PROP.  
SITE PLAN  
DOCUMENTS  
FOR

PROPOSED  
DEVELOPMENT

S MAIN ST & VIRGINIA WATER DR  
ROLESVILLE, NC 27587  
WAKE COUNTY

SHEET TITLE:  
**EXISTING  
CONDITIONS/  
DEMOLITION  
PLAN**

C-301

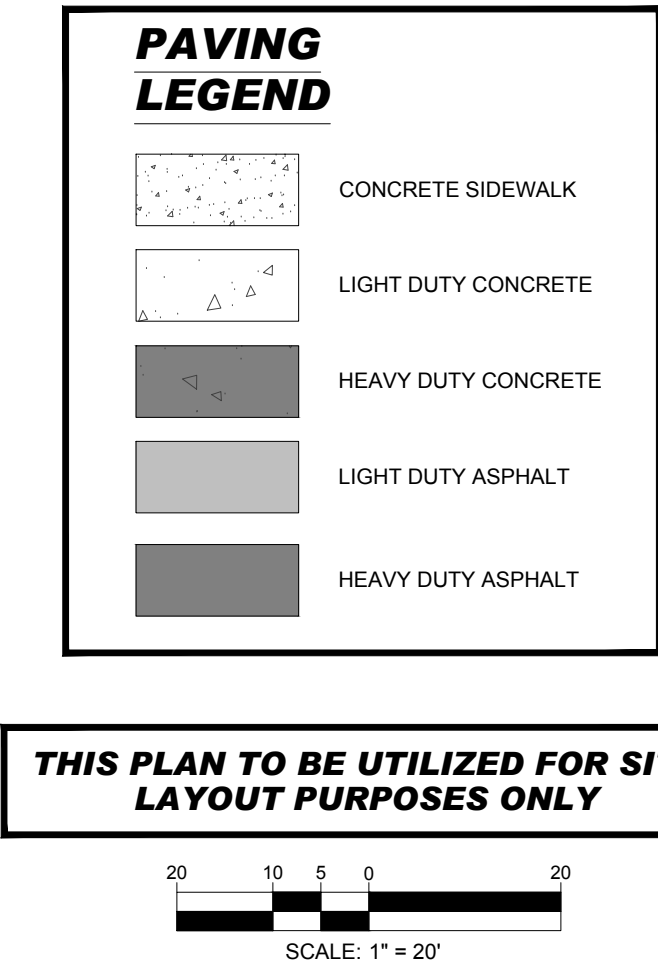
#5 Update plans to reflect surveyed conditions. (Leaving comment until survey is received and plans updated)

#15 Retaining wall in ROW won't be allowed by NCDOT; revise design

#16 Please label radius

#18 Plans for access drive has not been submitted. Unless further coordination for this access drive is taking place, design and permitting of driveway improvements will be needed for this submittal

#16 Please label radius

C-401

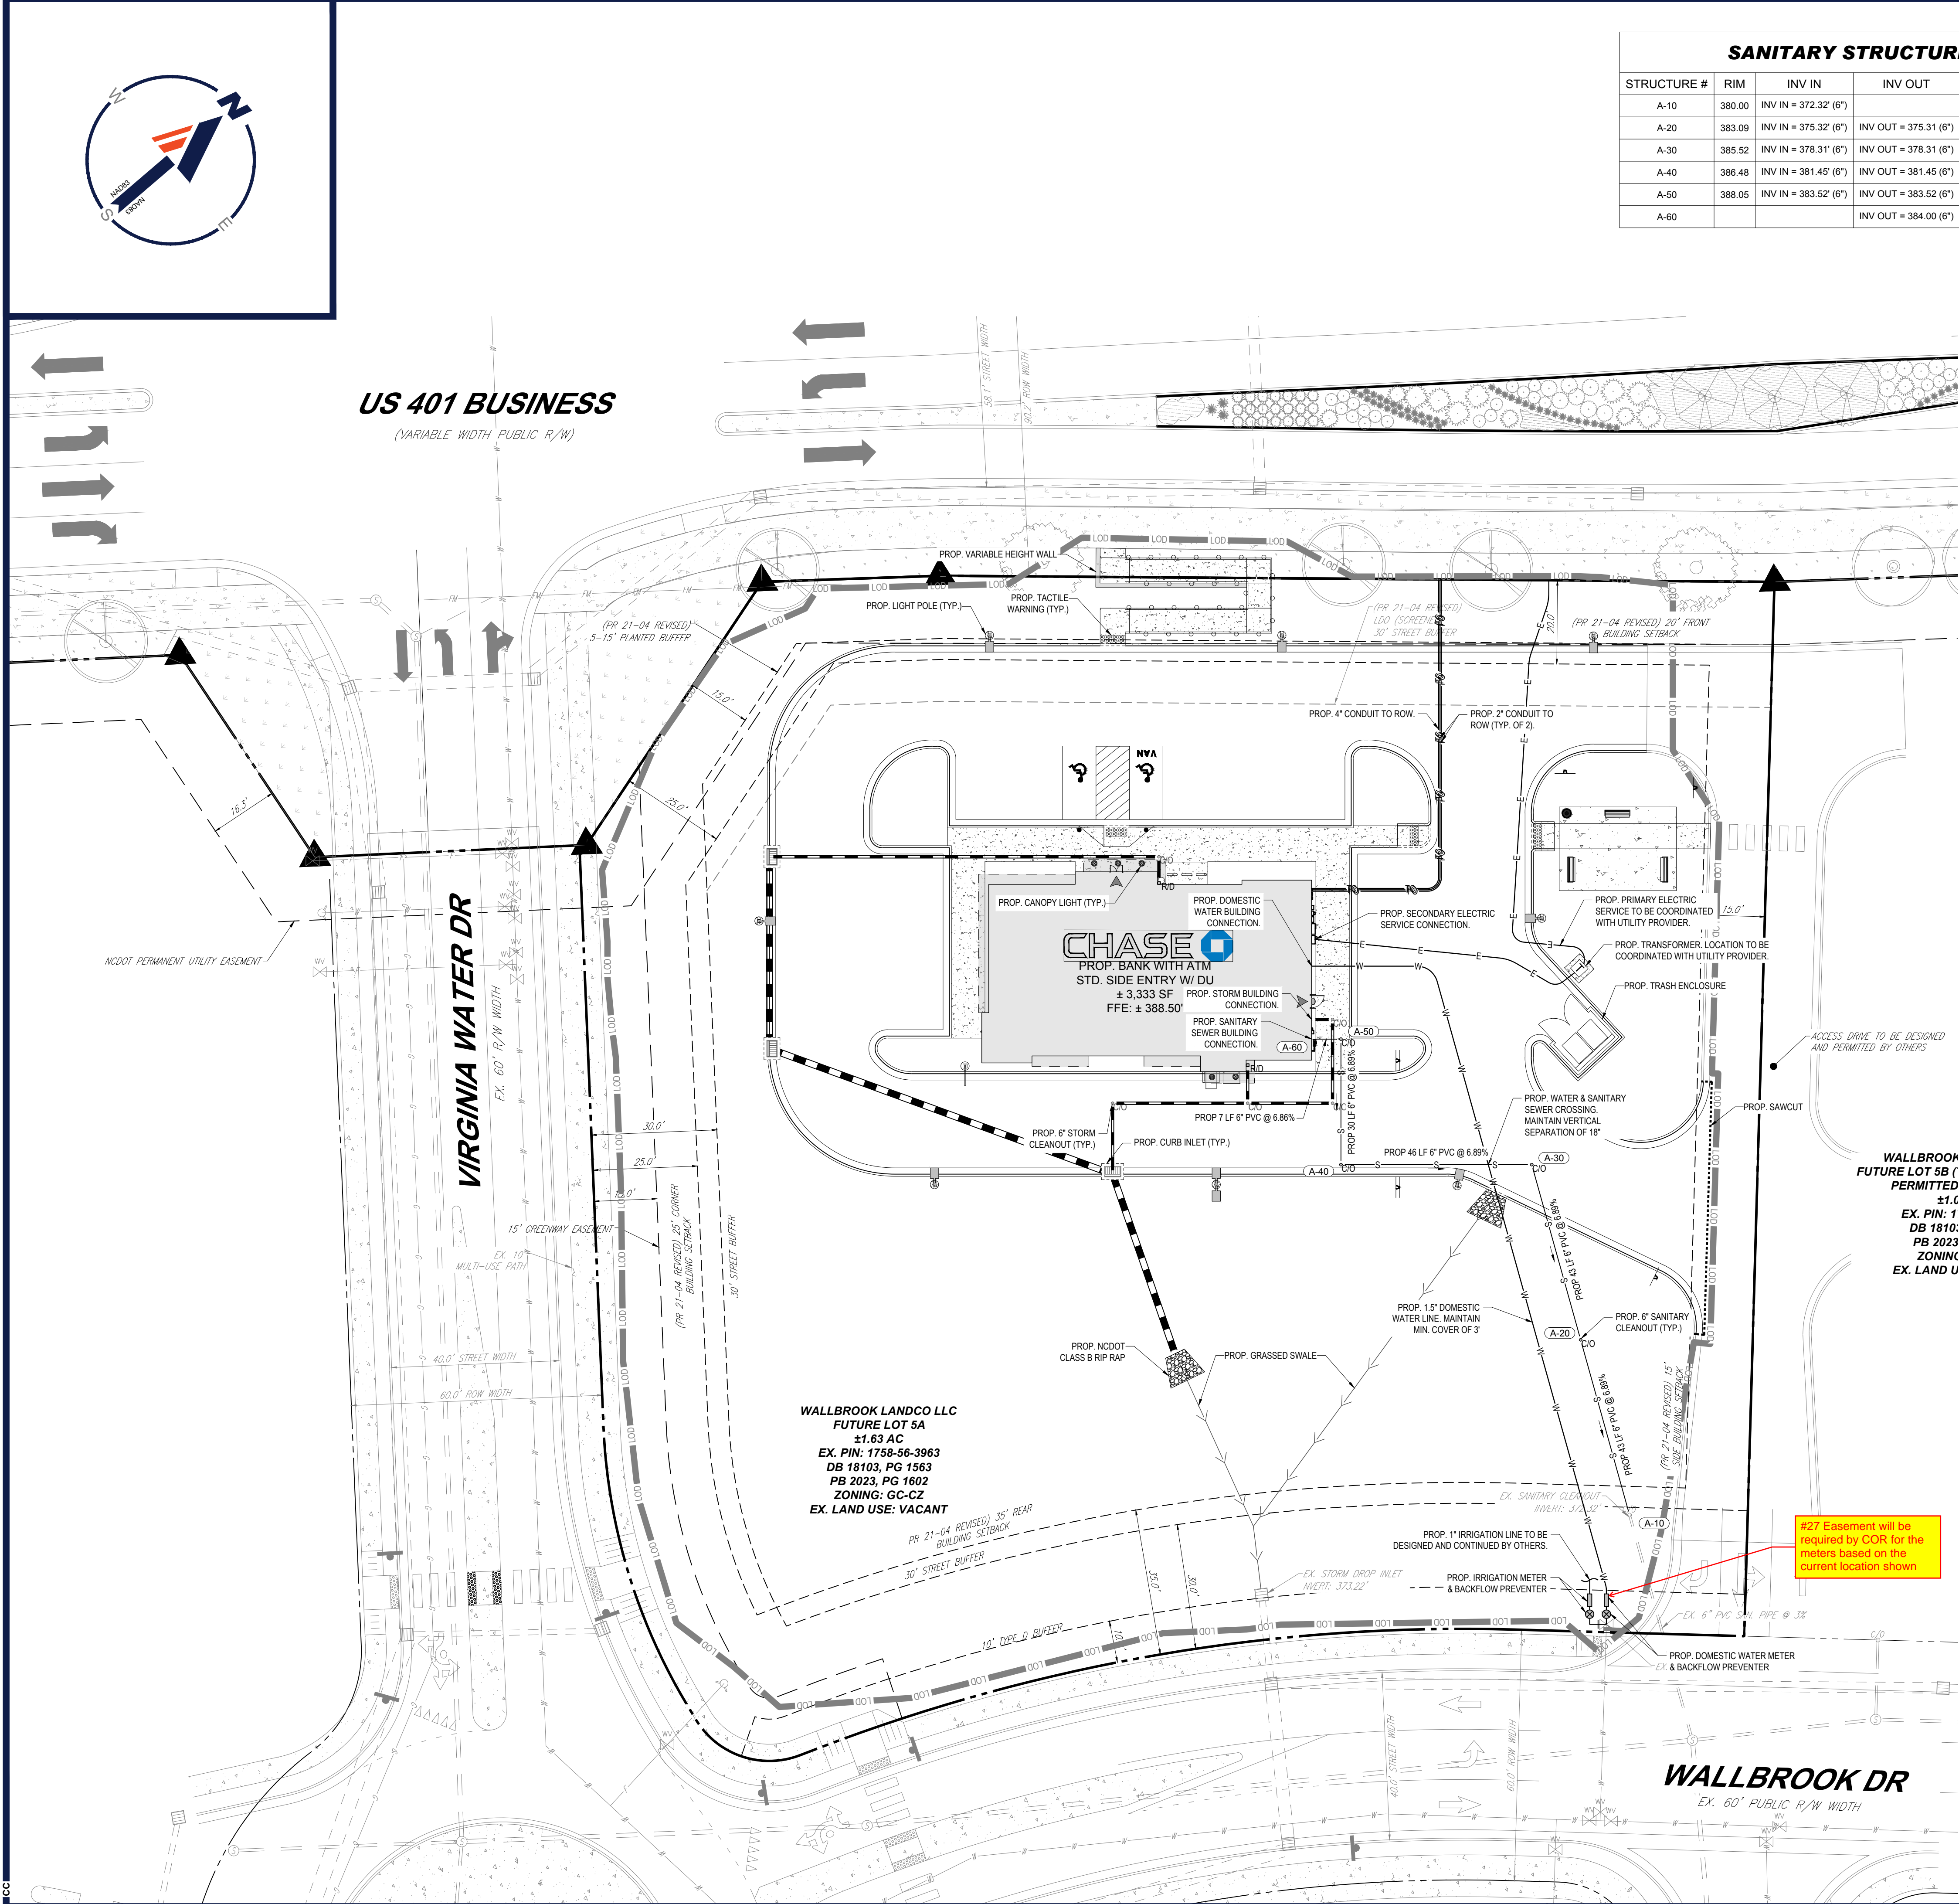
#13 Label  
storm pipe  
size

#22 Clarify if a spill curb  
be used along interior  
curb to release storm  
drainage?

#21 Clarify how water will  
be managed in low point  
at 282 contour

#20 Depending on  
revisions, please provide  
spot grades at proposed  
wall tie out locations

#23 Please clarify if there  
will be a low/high spot  
between 387 contours or  
adjust contour

#24 Appears to be  
possible drainage issue  
out of trash enclosure,  
adjust contours to allow  
enough grade out of  
trash enclosure

#25 Not able to evaluate  
grass swale based on not  
providing drainage areas.  
Impervious areas should  
be collecting through a  
closed storm system to  
existing drop inlet.

#26 Appears that area in  
east corner of site will  
sheet flow off site,  
ensure all stormwater on  
parcel will be collected.  
Additional swale?

#5 Update plans to reflect surveyed conditions. (Leaving  
comment as a note until survey is received)

#19 Please provide drop of 0.2'  
between invert in and invert out

**BOLLARD MOUNTED ADA PARKING SIGN DETAIL**  
NOT TO SCALE

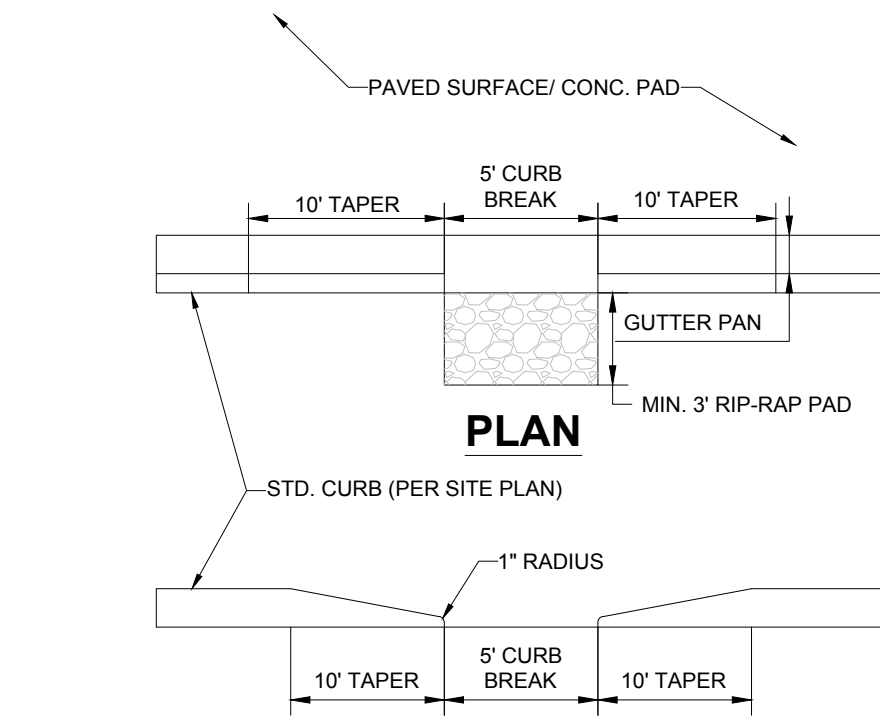
Stop bar and sign details?
